Subject Lug nut size change on 19MY Yaris SD MEX-Prod		Market USA
Service Category Suspension	Section Tire/Wheel	
Applicability 19MY Yaris (WMI=3MY)

Picture1. Different size lug nuts

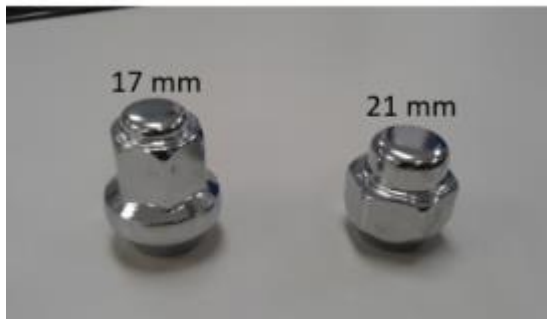
- 1) Lug nut size change from 21 mm to 17mm was implemented on 9/10/2018.
- 2) The 21mm wheel locking nut will not work with the OE wrench (since it is for 17mm nuts).

- Only use part number PT276-12160 for vehicles built on 9/9/2018, or before, and for 18MY.
- **DO NOT** use part number PT276-12160 on 19MY vehicles built after 9/9/2018. See pictures below for reference.
